Notice of Decision CERTIFICATE OF APPROVAL

Re: **RM of Lumsden No. 189**
NE ¼ & NW ¼ 8-19-21-W2M

[REDACTED]
Residential Subdivision

Under Sections 128 (4) c) ii) and 129 of *The Planning and Development Act, 2007*, the proposed subdivision shown within the bold dashed line on the attached plan is hereby **APPROVED** subject to compliance with the following directives regarding development standards issued under Section 130 of the Act.

DEER VALLEY
 PLAN OF SURVEY
 SHOWING
 SURFACE SUBDIVISION
 OF PART OF
 PARCEL A
 PLAN NO. 101174082
 N.W. 1/4 SEC. 8, TWP. 19, RGE. 21, W. 2 Mer.
 R.M. OF LUMSDEN NO. 189
 SASKATCHEWAN
 BY: [REDACTED]
 DECEMBER, 2008
 SCALE 1 : 1000

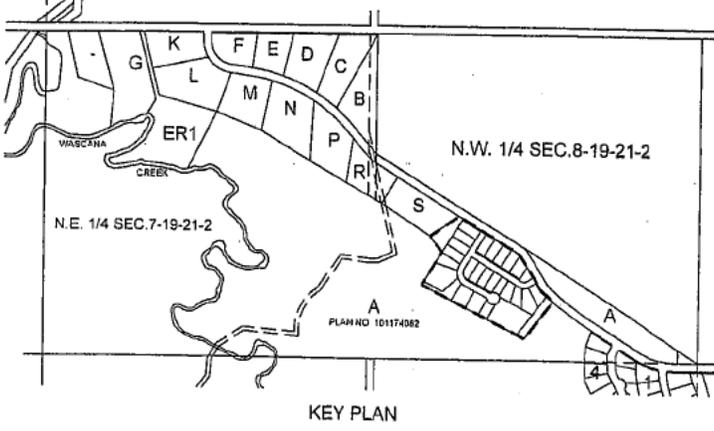
1. The Report identifies safe building areas, as shown on the attached plan. To minimize the potential problems associated with slope stability, the following guidelines are provided for development at this time. Construction of all buildings or structures shall only occur within the identified geo-technically recommended safe building area.

THE SUBDIVISION SHOWN WITHIN THE BOLD DASHED LINE IS HEREBY APPROVED AS PER THE ATTACHED NOTICE OF DECISION

SITE PLAN SHOWING LOCATION OF TEST HOLES
 PROPOSED [REDACTED] SUBDIVISION
 DEER VALLEY, SASKATCHEWAN

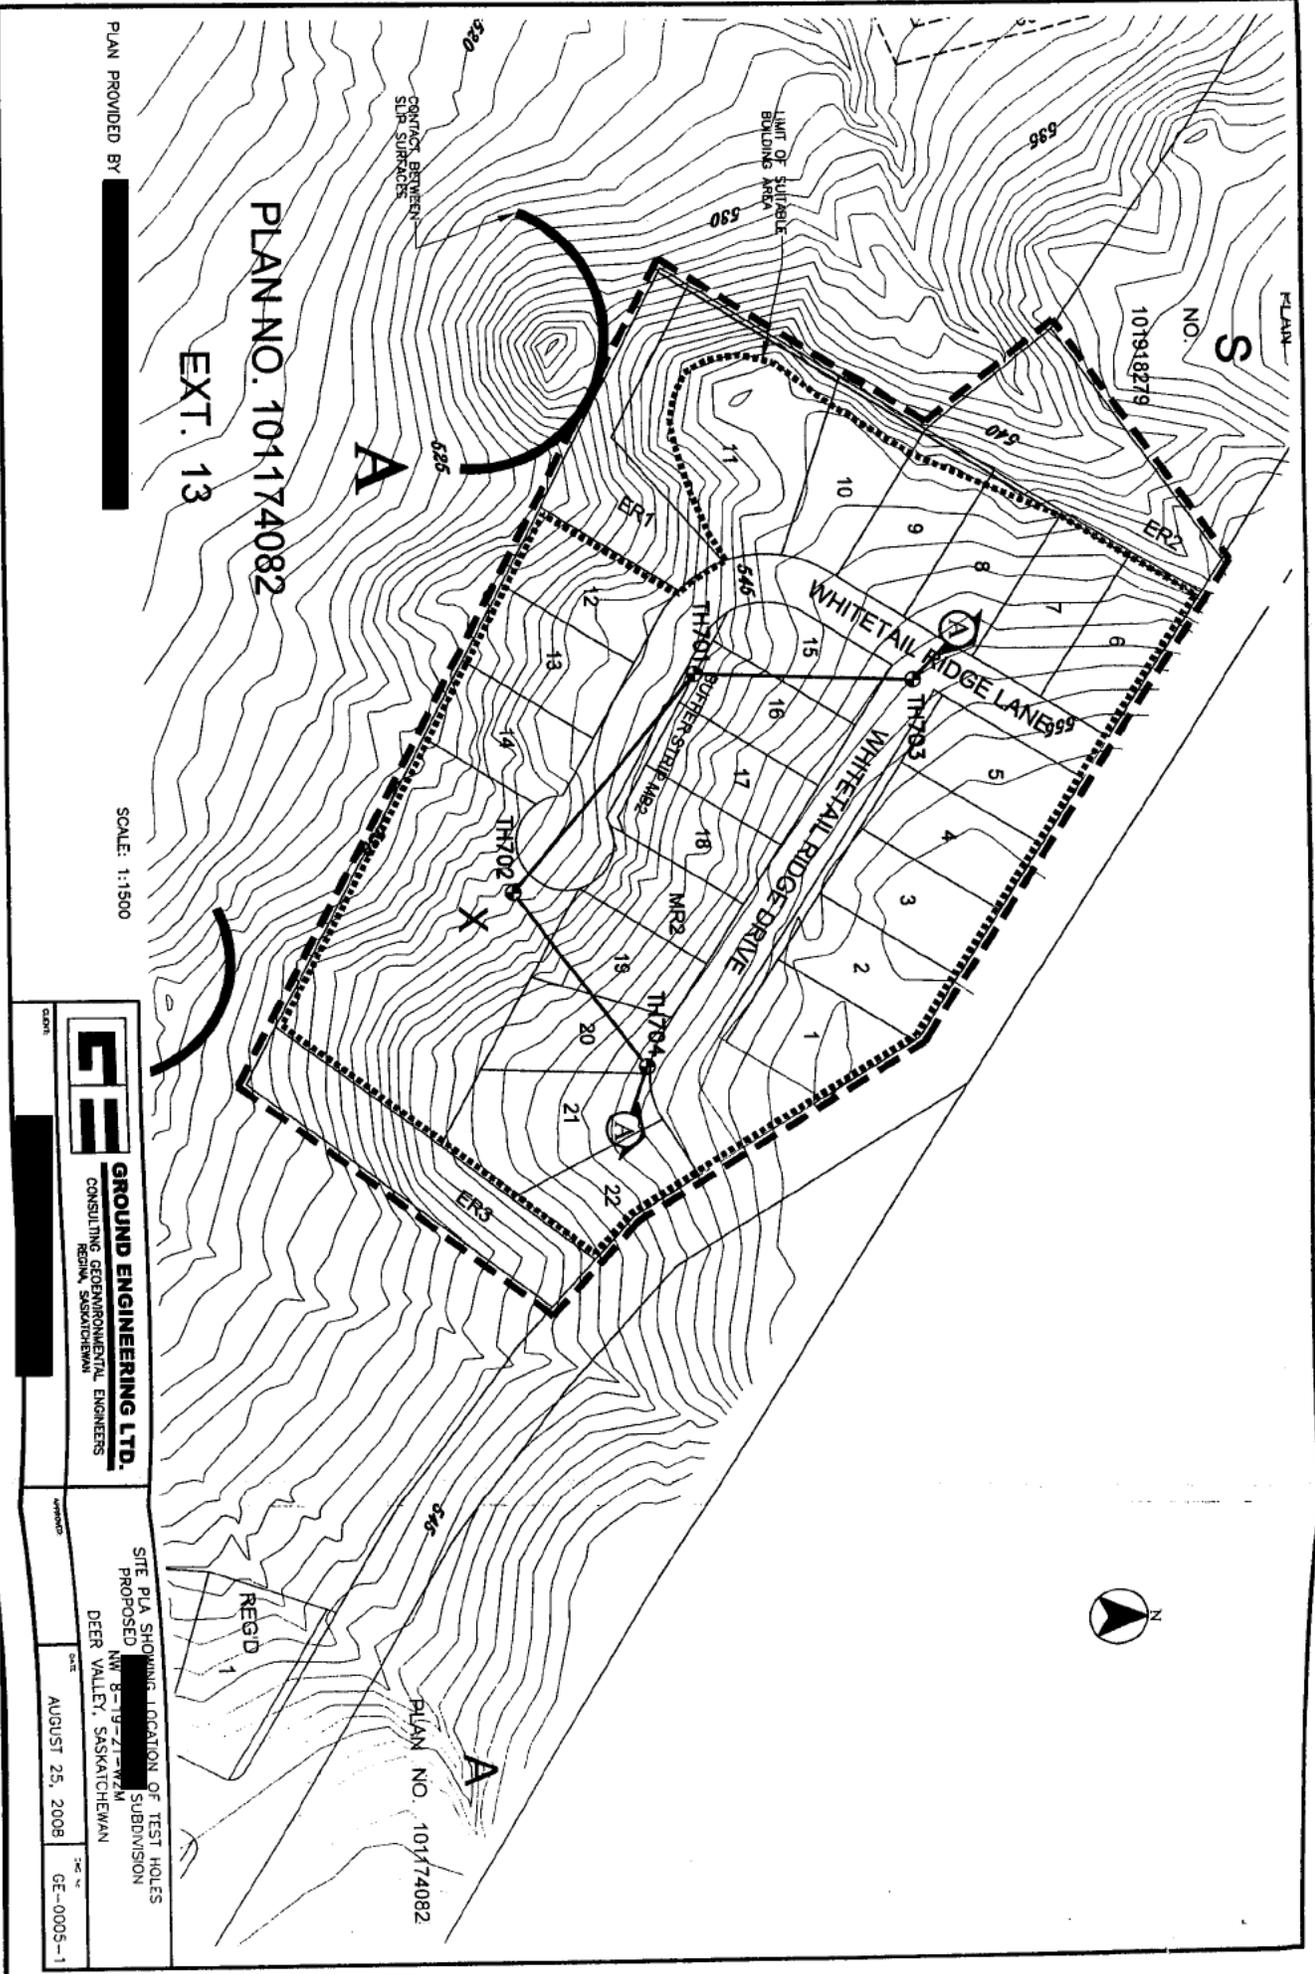
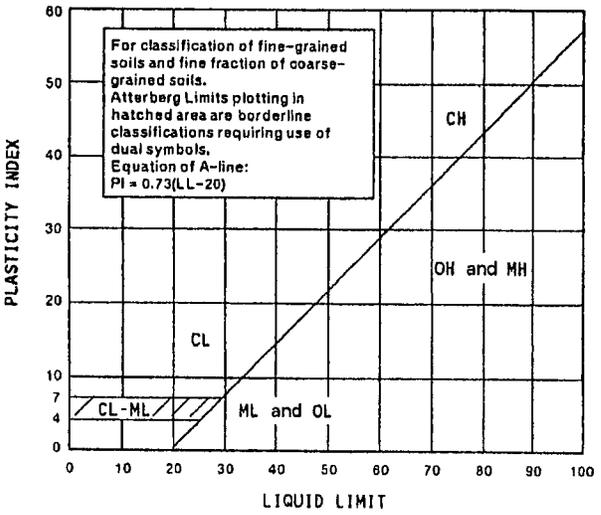
2. Buildings constructed in landslide terrain should be located entirely on one (1) slump block. Therefore, if movement occurs, the building would move with the block so that only minor damage would occur to the structure. If a building is constructed across two (2) slump blocks, the blocks may move at different rates and cause severe damage to the building. The contact areas between slump blocks which were identified in their preliminary inspection shown on Drawing No. GE-0005-1

2000 (included in Appendix A) for areas with highly plastic clay are applicable to this development. The only exceptions are that the minimum pile length may be reduced to 5.0 metres for the 22 proposed residential lots. The minimum recommended pile length for the condominiums remains at 6.0 metres. The buildings may be constructed anywhere on the property with the exception of portions of Lots 8, 9, 10 and 11, as shown on Drawing No. GE-0005-1.
